STAFF REPORT AMENDED 7-12-84  
CITY PLANNING COMMISSION

LOCATION: 1300-1328-14th Street

PROPOSAL: The applicant is requesting the necessary entitlements to convert an existing warehouse commercial building into office use and locate the parking off site on an adjacent parcel.

APPLC. NO. P84-209

**SITE PLAN & FLOOR PLAN**  
 Sheet No.

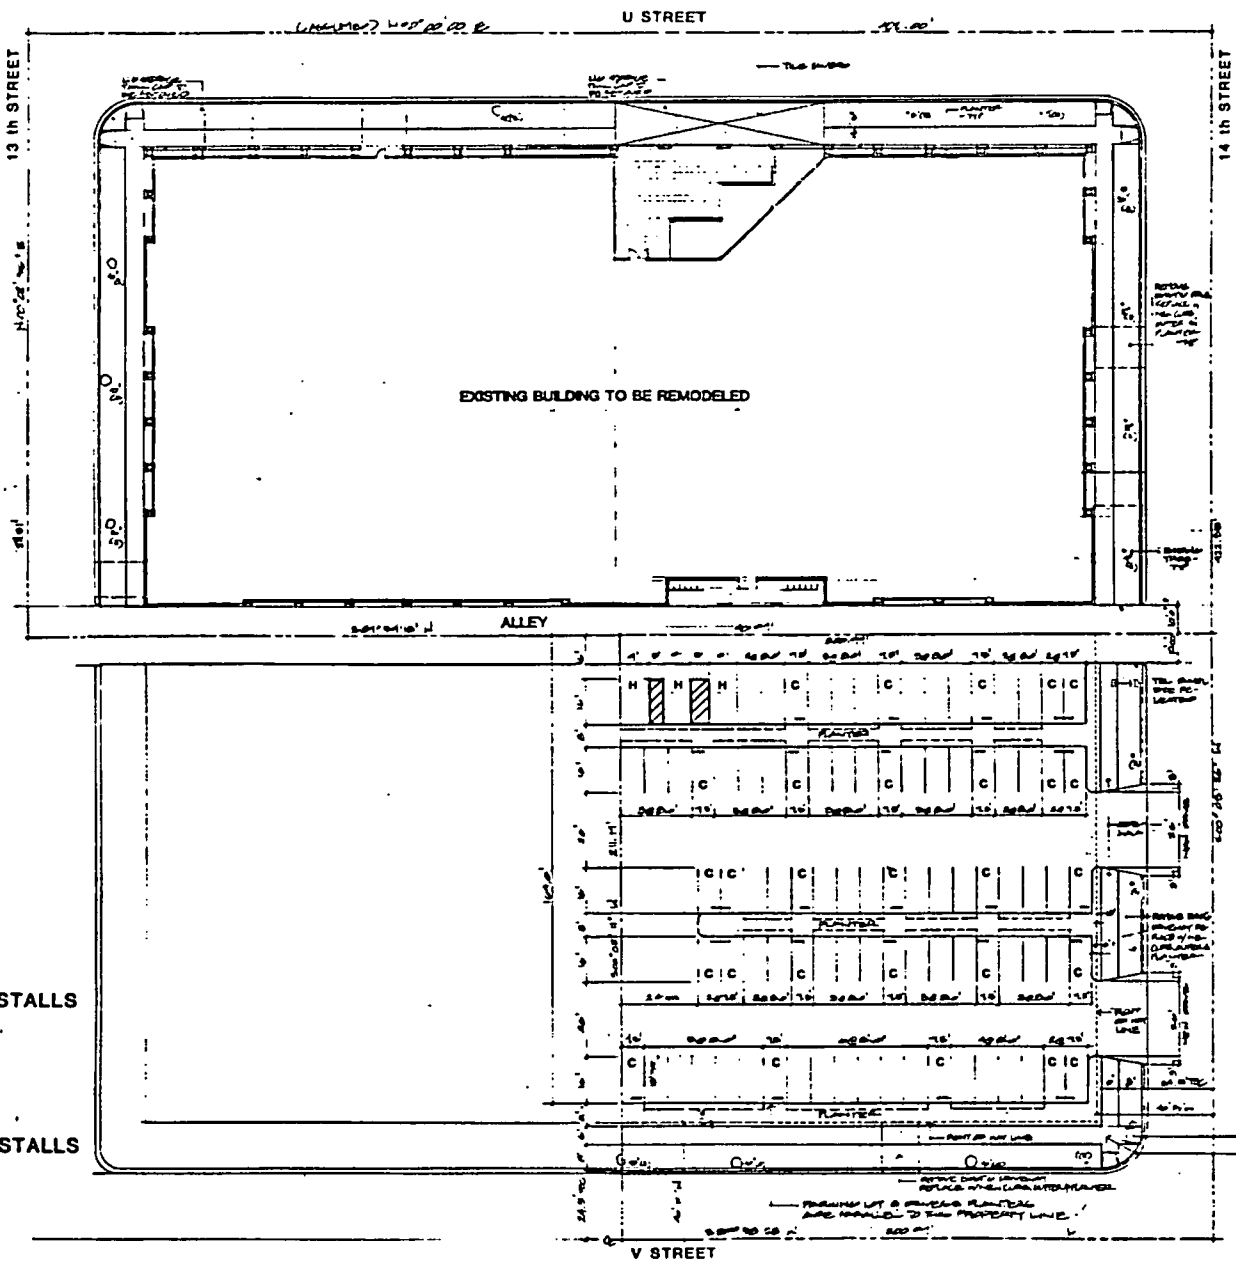
- C. The applicant's plans were reviewed by the City Engineer and the Traffic Engineer. The City Engineer indicated that a revocable encroachment permit is required for the planters and that the applicant will be required to replace curb, gutters, sidewalks to the satisfaction of the City Engineer and to construct street lights. The Traffic Engineer expressed concern over parking problems in the area and indicated that the applicant shall meet the parking requirement for office use. The Traffic Engineer also recommends the encroachment of the planter areas in the public right-of-way be denied since the applicant's proposal will interrupt the sidewalk alignment and jepordize the health of the existing street trees. The Traffic Engineer is also requiring the following provisions:

1. Align the sidewalks at the alley on 14th Street;
  2. Provide on-site trash enclosures;
  3. Redesign the parking to provide circulation between the alley and off-site parking stalls;

4. Remove all existing driveways and reconstruct sidewalks;
  5. Remove the underground storage tanks.
- D. The applicant will be required to meet the 50 percent shading requirements. Detailed landscape, shading and irrigation plans shall be submitted for staff's review and approval.

- E. Staff concurs with the City Traffic Engineer in that the requested variance to encroach on the City right-of-way with required planters should be denied. As proposed, the applicant will only be providing two and one-half feet of the required planter on the site along 14th Street. Since the site is adequate in size to provide more than the required parking, staff can find no hardship to warrant this request. A total of five parking spaces would be eliminated if the required planter is provided along 14th Street. The applicant is providing an excess of 25 spaces on this parking lot.

3. The applicant shall submit revised parking lot plans for the review and approval of the City Traffic Engineer prior to issuance of a building permit. *The applicant shall submit revised plans for review and approval by staff (CPC added)*

4. Detailed landscape, shading and irrigation plans shall be submitted for staff's review and approval prior to issuance of a building permit.
5. The revised site plans shall indicate the location and design of an on-site trash enclosure. Plans shall be submitted for staff's review and approval prior to issuance of a building permit. The trash enclosures shall be screened with a six-foot high masonry wall with a metal gate.
